Arizona Public Service Company

Subject: Final Report - DER 83-29  
A 50.55(e) Reportable Condition Relating to Two Hangers In  
Unit 1 Safety Injection System Were Not Installed As Designed.  
File: 83-019-026; D.4.33.2

FINAL REPORT - DER 83-29  
DEFICIENCY EVALUATION 50.55(e)  
ARIZONA PUBLIC SERVICE COMPANY (APS)  
PVNGS UNIT 1

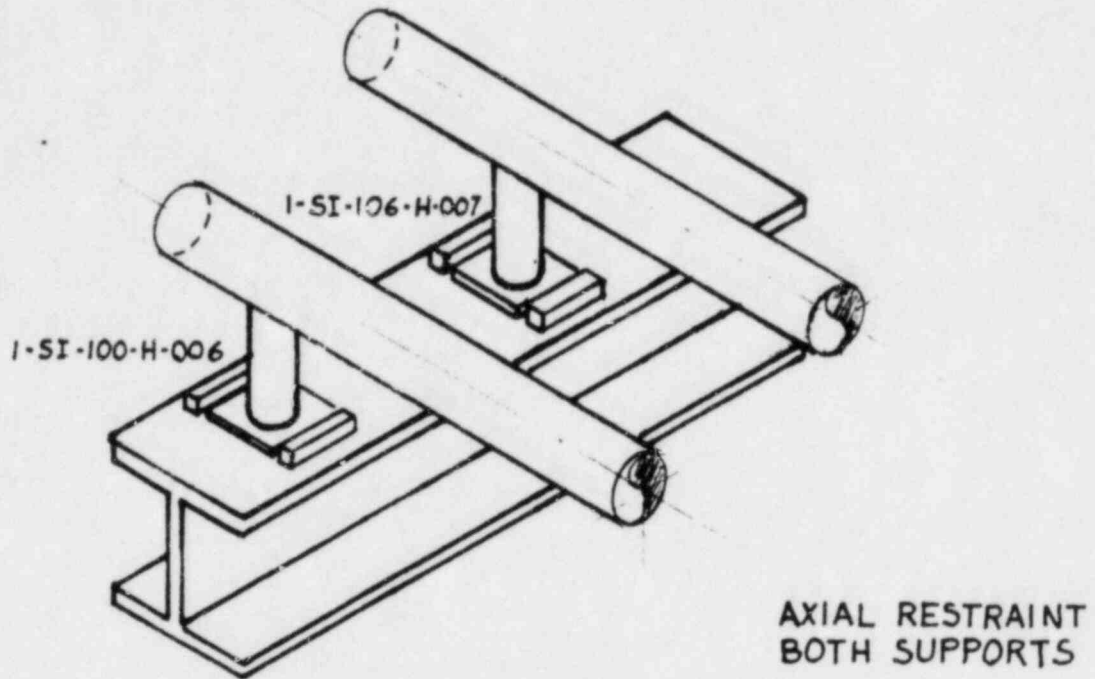
Pipe hanger drawings 13-SI-100-H-006 and 13-SI-106-H-007 specify axial restraints for Safety Injection System pipes SI-100-CCBA-4" and SI-106-CCBA-3", respectively, by indicating 1"x1/2"x0'-4" long bars attached adjacent to the north and south sides of each pipe dummy stub base plate (2 bars per base plate). The restraining bars for both hangers, shown on drawing 13-SI-106-H-007, are referenced by drawing 13-SI-100-H-006. As described in Nonconformance Report (NCR) PA-6143, all four bars were installed around the base plate for hanger 1-SI-106-H-007, restraining transverse as well as axial pipe motion. Hanger 1-SI-100-H-006 was left with unrestrained axial motion (see attached sketch). The subject condition is attributed to a misinterpretation of design drawings arising from having all four restraint bars drawn on one support drawing.

1. NCR PA-6143 will be dispositioned to have supports 1-SI-100-H-006 and 1-SI-106-H-007 repaired per the design drawings.
2. To preclude recurrence, drawings 13-SI-100-H-006 and 13-SI-106-H-007 are being revised to clarify restraint bar locations.
3. This condition has been verified to be an isolated event. The attached tabulation provides a list of all Q-Class pipe supports having dummy stubs. Based upon a review of the associated drawings, 65 support designs were identified with base plates restrained by bar stops. Of these, only two subject supports used cross-reference on one support drawing and located the restraint bars for both on the other support drawing.

DESIGN CONFIGURATION

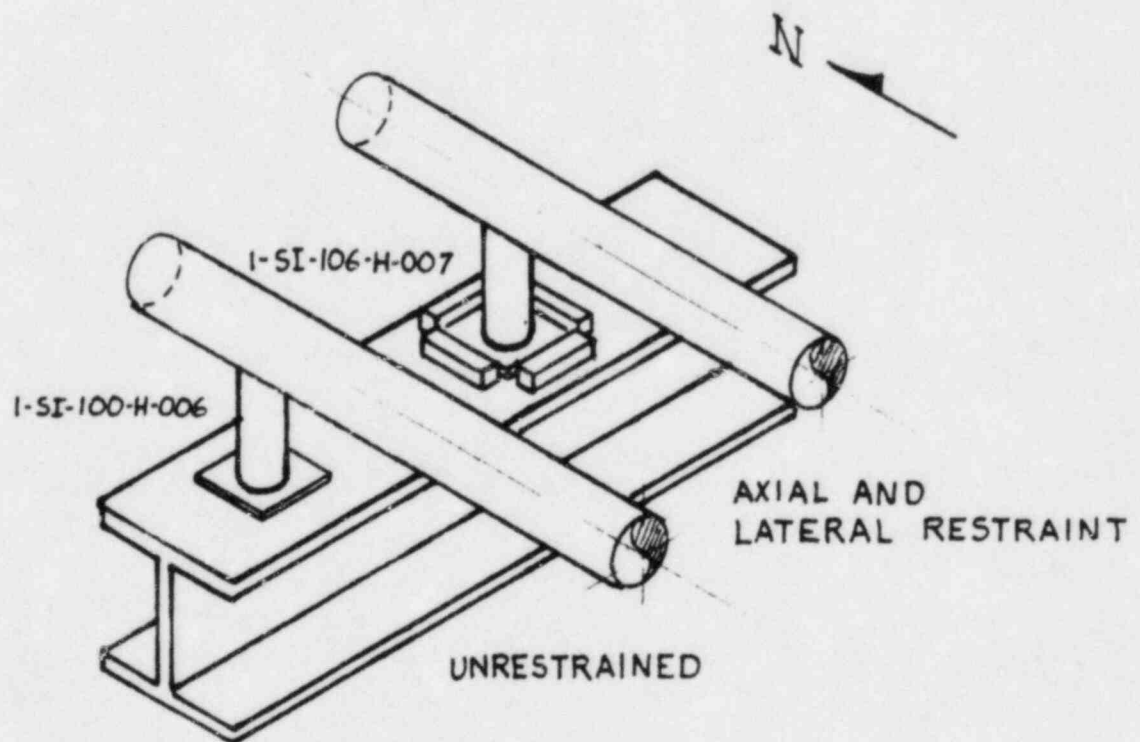
The associated piping systems were analyzed for the installed restraint configurations. Results of the evaluation show that line SI-100-CCBA-4" would have acceptable stress levels and support loads should no axial restraint be provided at support 1-SI-100-H-006. Although the stress levels of line SI-106-CCBA-3" would be acceptable, support 1-SI-106-H-003 would have inadequate load capacity to withstand additional forces imposed by a transverse (E-W) restraint at hanger 1-SI-106-H-007. The subject condition is therefore evaluated as reportable under the requirements of 10CFR50.55(e) since it represents a significant deficiency in construction such that, if left uncorrected, it could adversely affect the safety of operations of the plant during the lifetime of the plant. A detailed analysis of safety implications was not pursued as the condition is being corrected.
